SUBMITTAL TO THE BOARD OF SUPERVISORS
COUNTY OF RIVERSIDE, STATE OF CALIFORNIA

SUBJECT: FACILITIES MANAGEMENT AND RIVERSIDE UNIVERSITY HEALTH SYSTEM: Riverside University Health System Medical Center Labor & Delivery Room, Neonatal Intensive Care Unit, and Pediatrics Accessibility and Reconfiguration Project - Approval of Revised Project Budget, Approval of Change Order No. 1 for Vincor Construction, Inc., and Approval of First Amended and Restated Professional Services Agreement with Westgroup Designs, Inc.; District 5. [\$571,428 - 100% RUHS Enterprise Fund 40050](4/5 Vote Required)

CHANGE ORDER NO. 1

RFI #28: Phase 2 - Window Framing

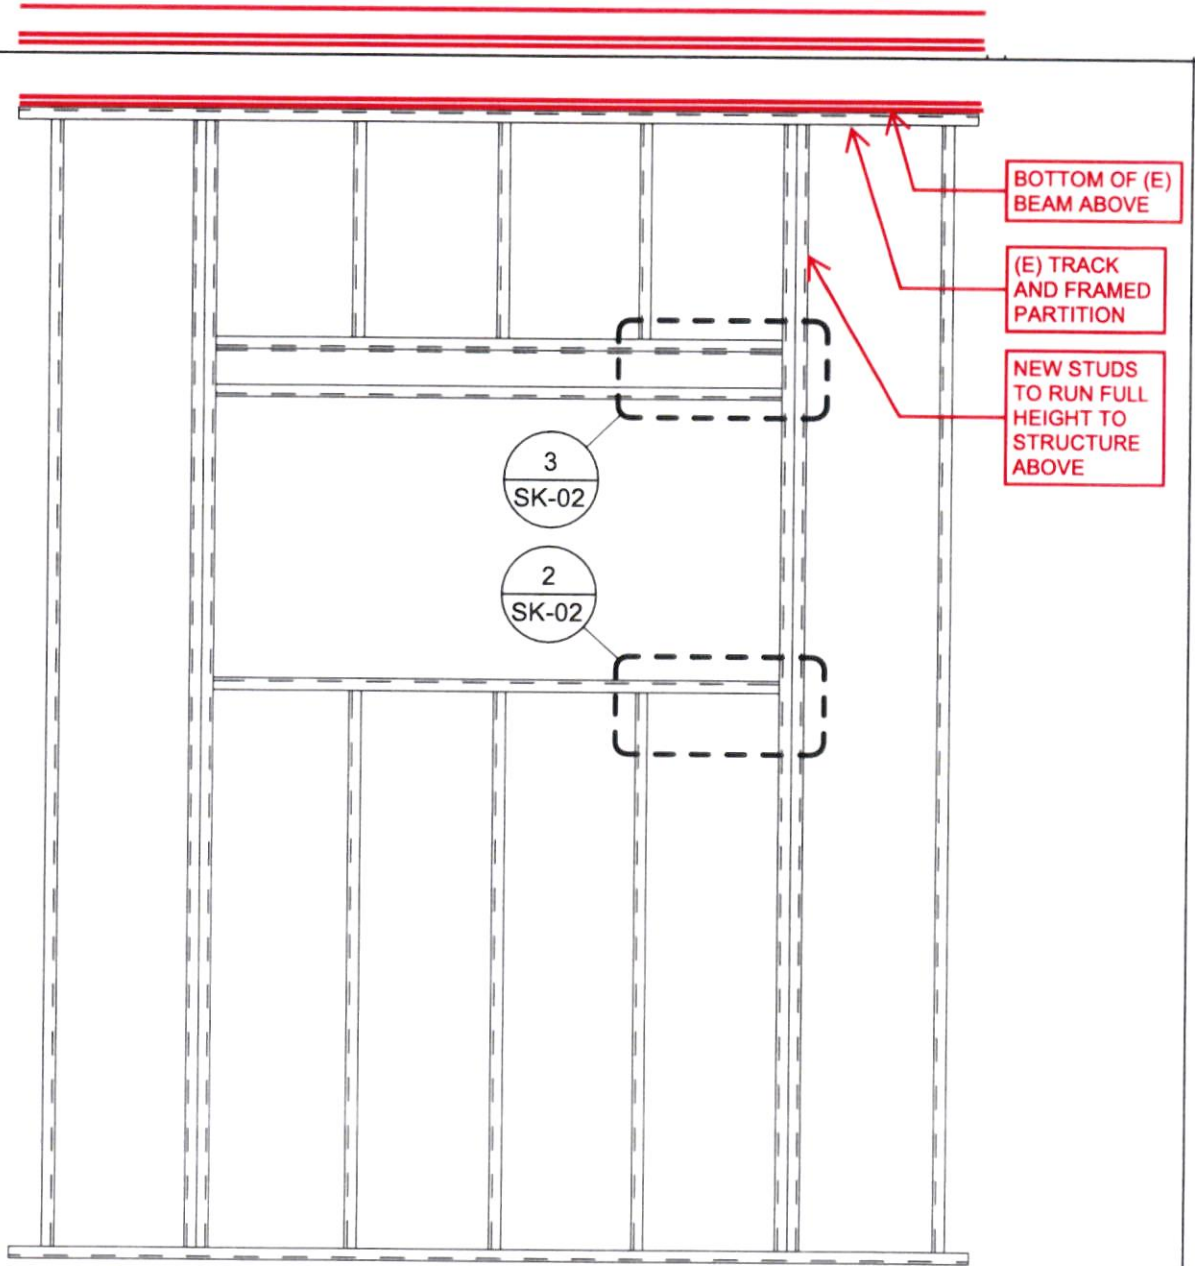
Question **Question from Mario Gonzalez Vincor Construction, Inc. on Friday, Dec 9, 2022 at 03:29 PM PST**
 Jon,
 Can you please confirm framing detail for phase 2 window?
 Thank you.
Attachments
[LDR NICU - Phase 2 Window Framing.pdf](#)

SK-01

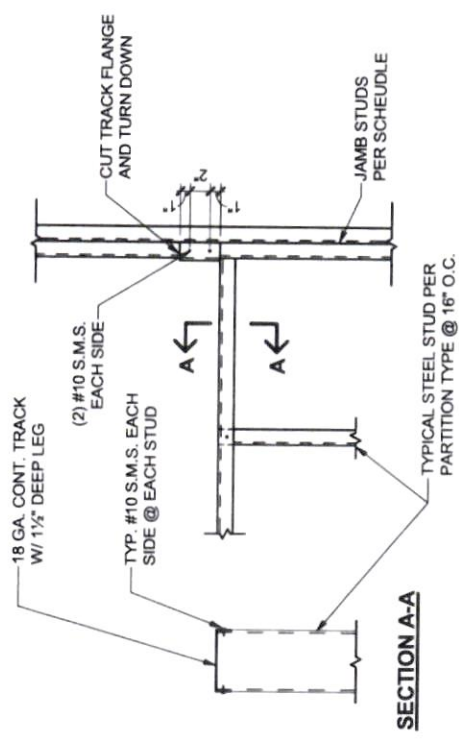
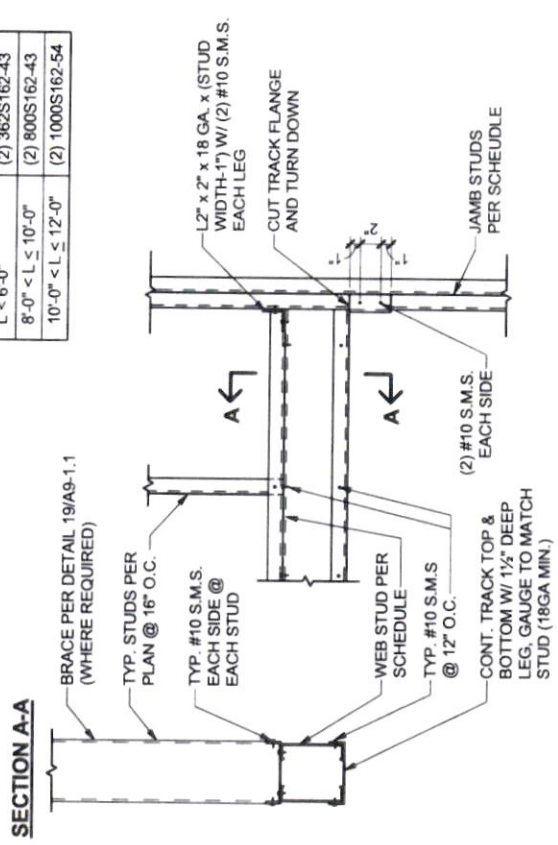
Provide new king studs to extend full height and attach to structure above to support window framing as per detail SK-01 – 03.

PARTITION OBSTRUCTION ALT DETAIL 1
RUHS LDR & NICU WAITING ROOM

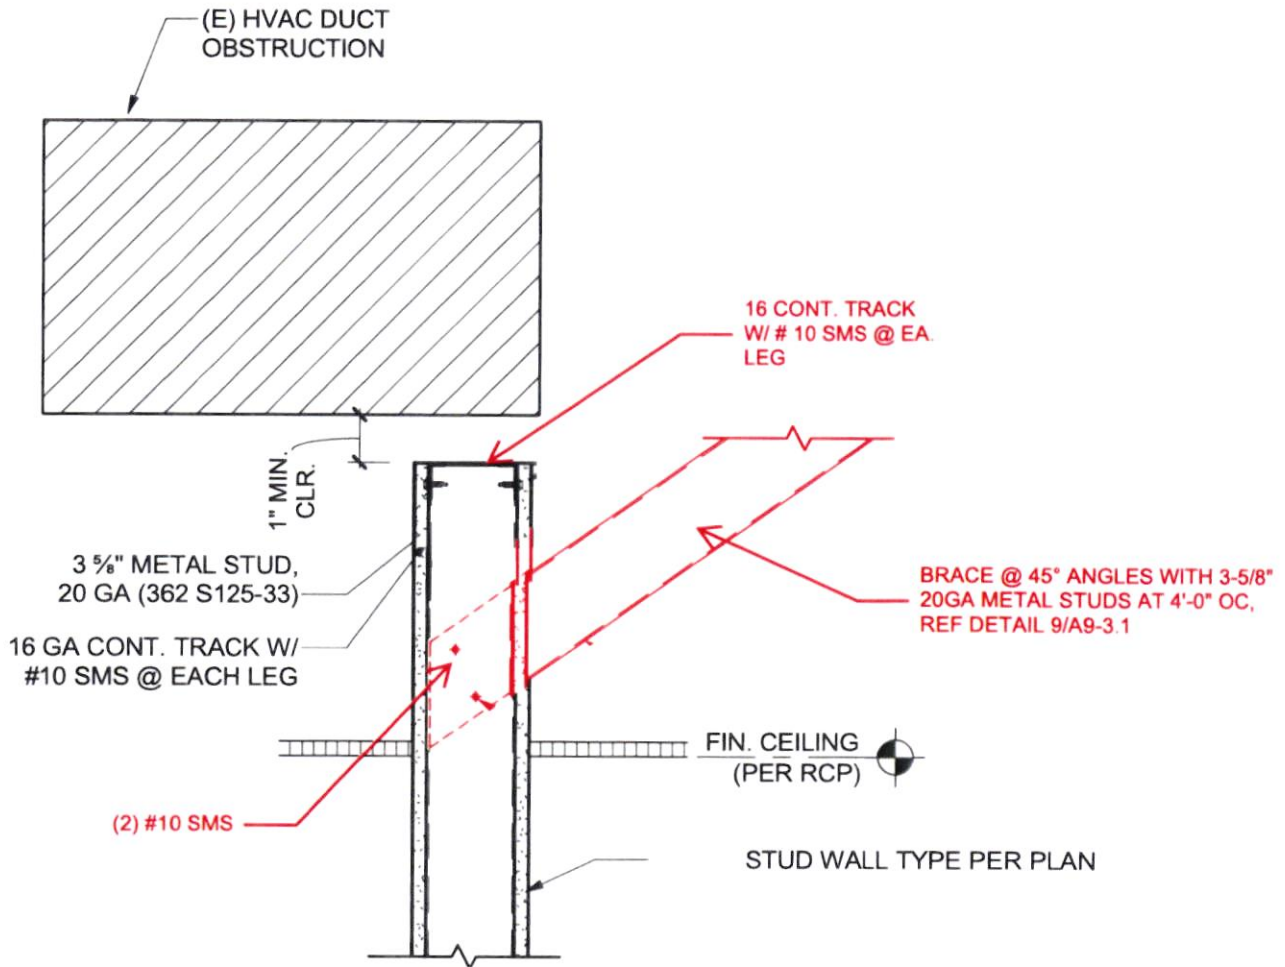
OPTION 1: ADD KICKERS DIRECTLY TO THE STUD WALL WHERE FRAMING STOPS
- RTM

RESPONSE: See attached sketch alternatives for top framing details around obstruction.

PARTITION OBSTRUCTION ALT DETAIL 2
 RUHS LDR & NICU WAITING ROOM

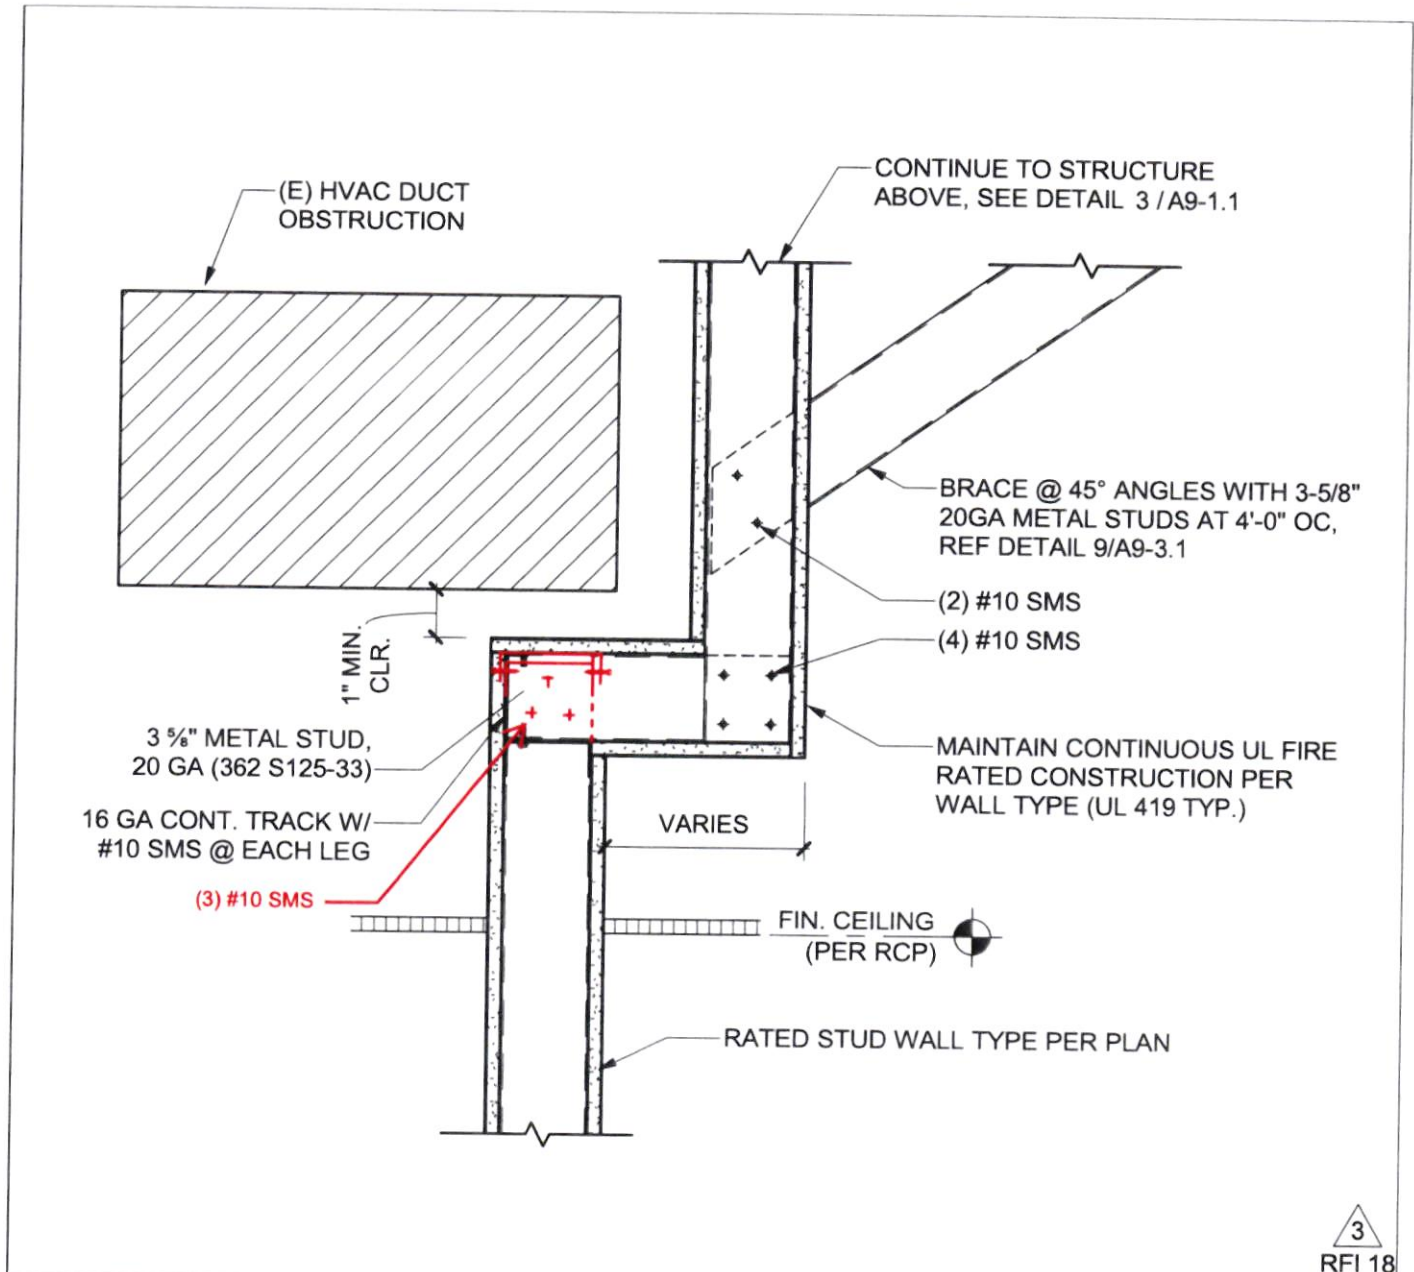
OPTION 2, JOG FRAMING AROUND HVAC AND ADD KICKER BRACING - RTM

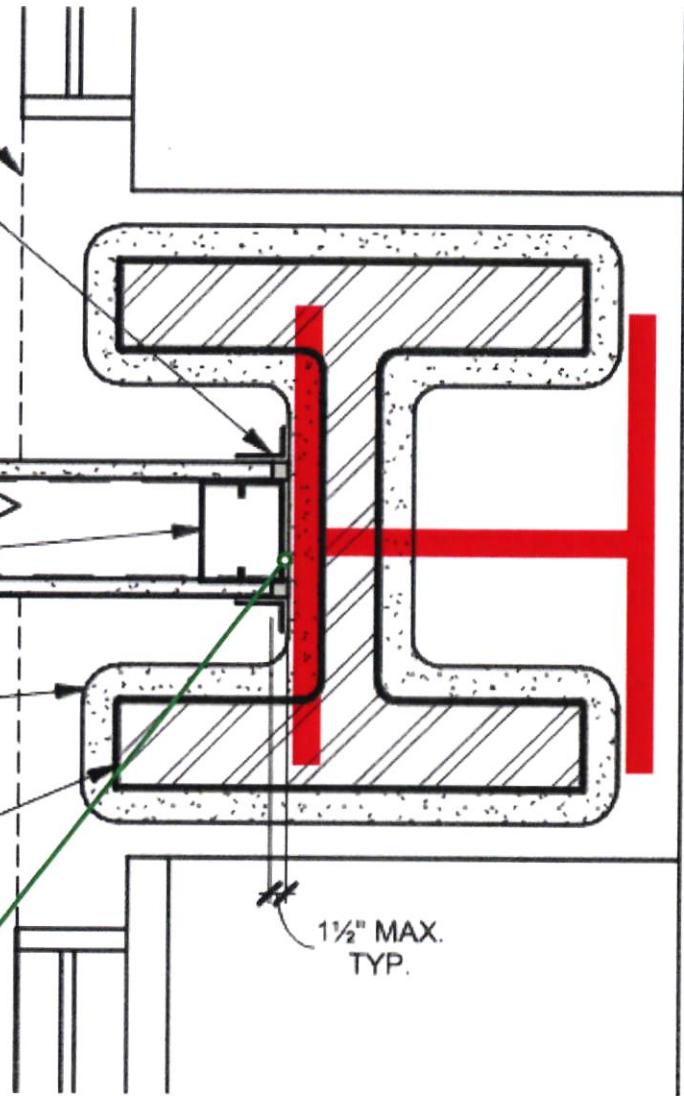
WD RESPONSE: Understand from contractor email that exterior column is rotated 90° from approved detail on RFI 32 (see markup on next page). Approved detail for freestanding double studs will still apply in new column orientation, team recommends not deviating from detail for z-clip attachments.
 If z-clip attachments are desired by installer, provide more info/sketch of proposed alternative (zclip/guage/spacing/attachment) for structural review.

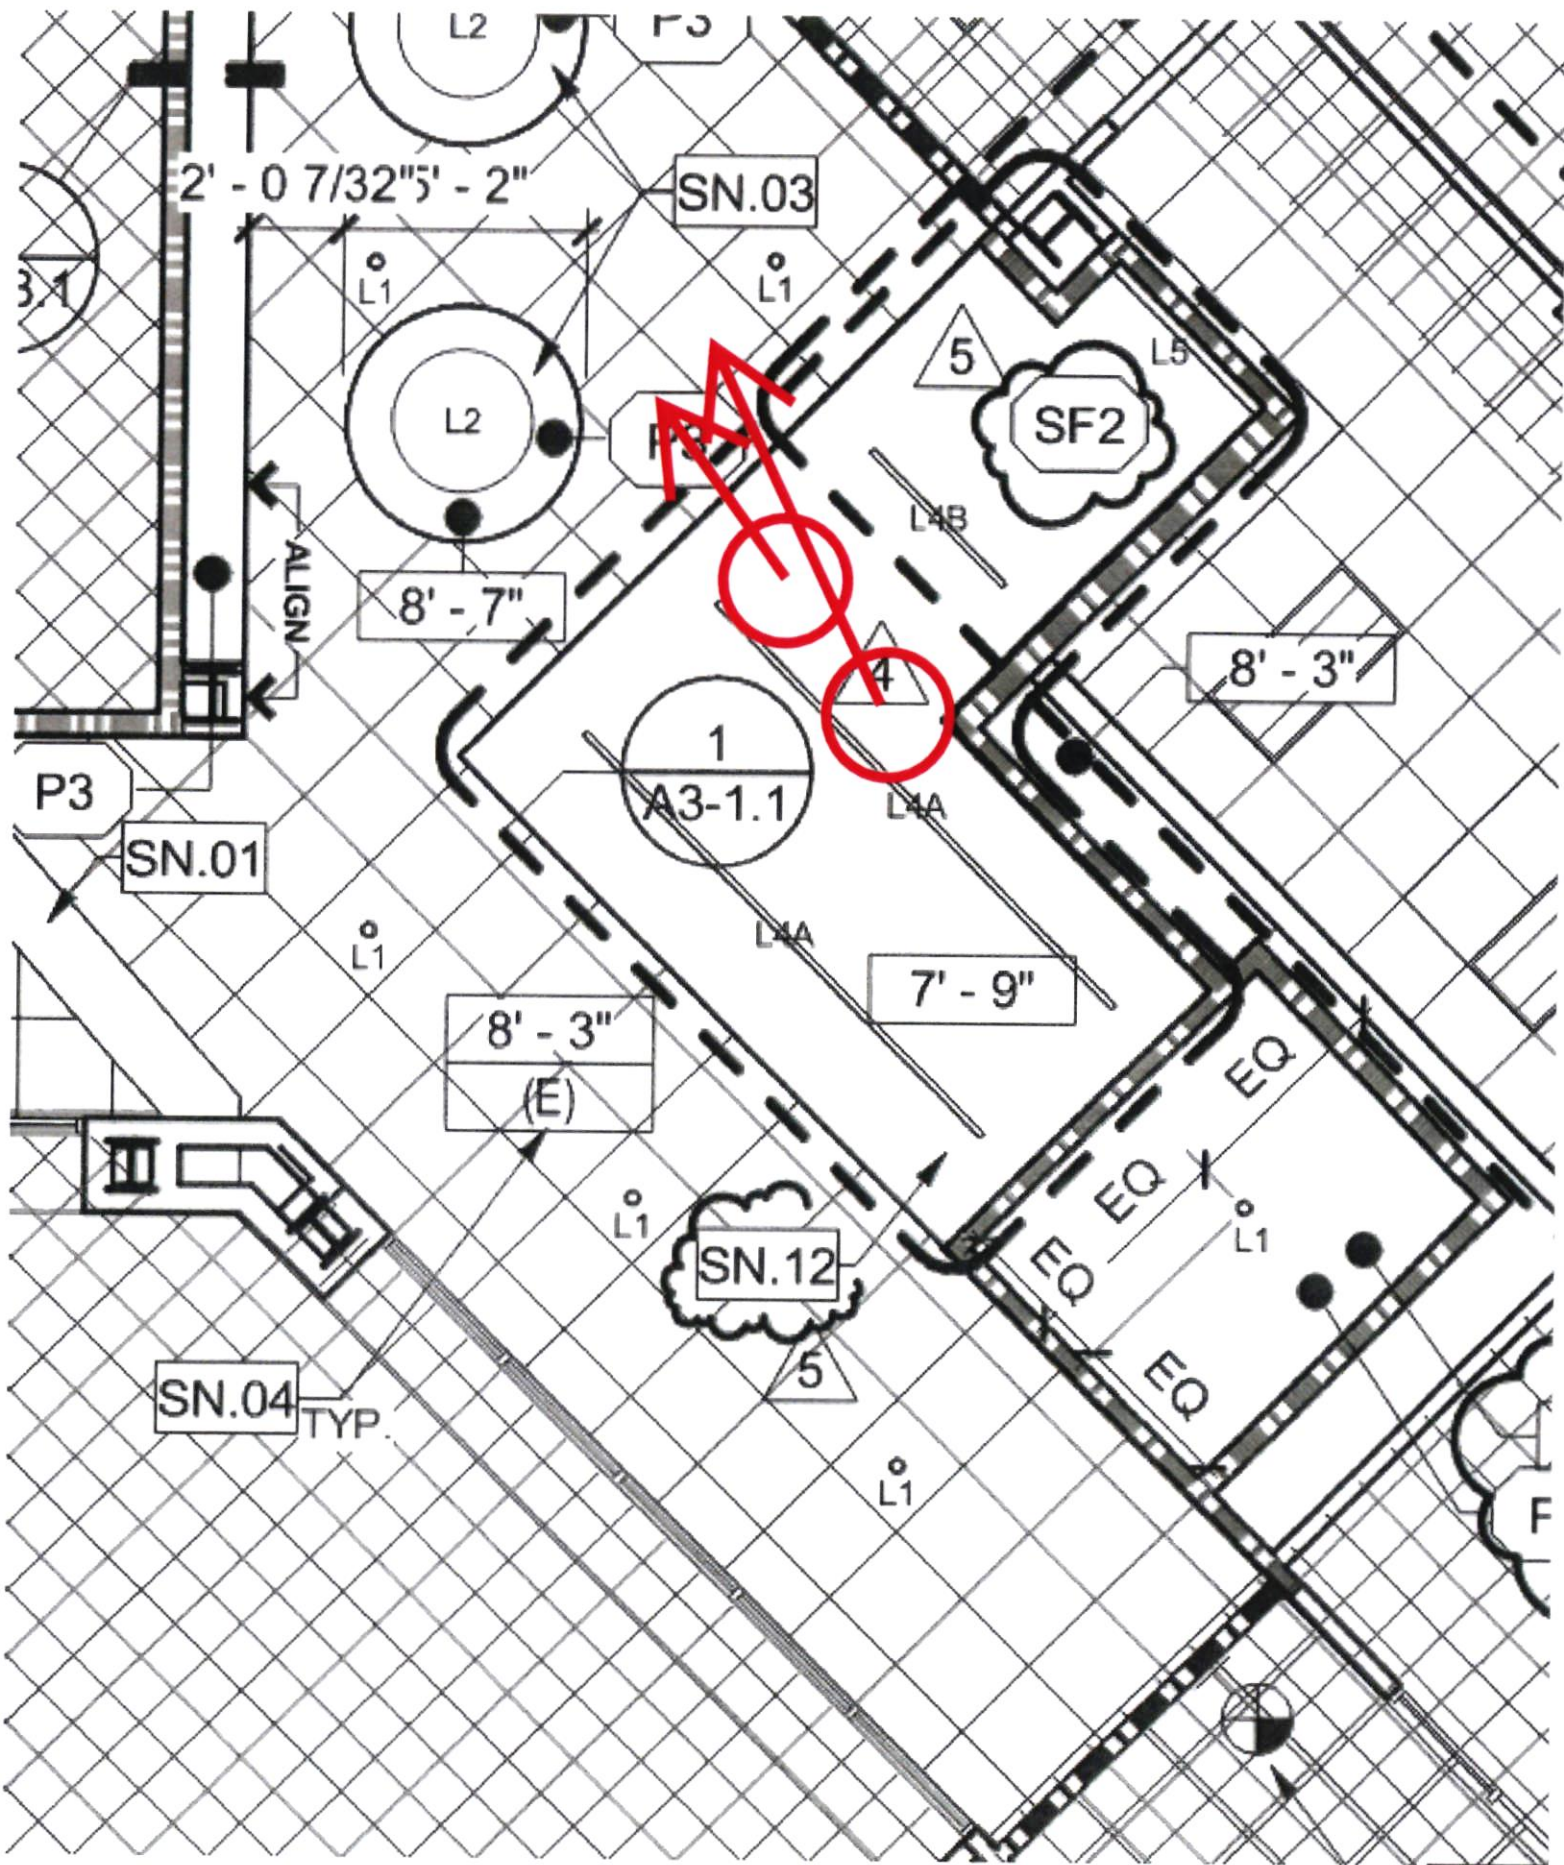
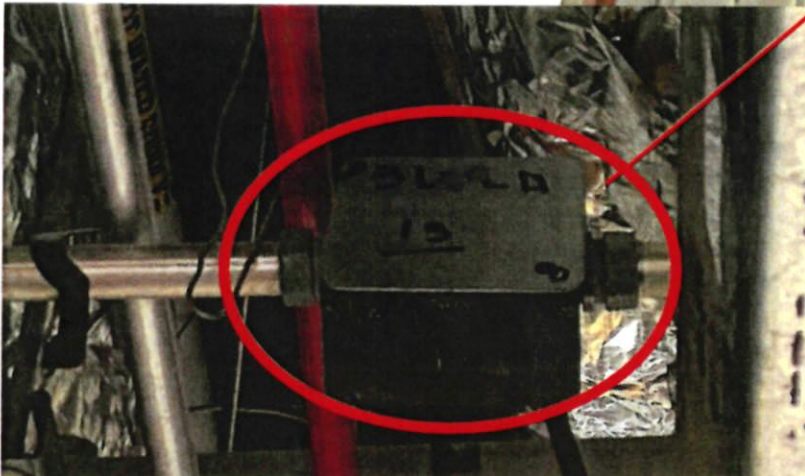
Hi Jon,
 There are 2 existing j-boxes above ceiling of our Reception Desk.
 Please provide direction if we can install access panels? or are we to relocate?
 Let me know if there is more information we could provide
 Thank you
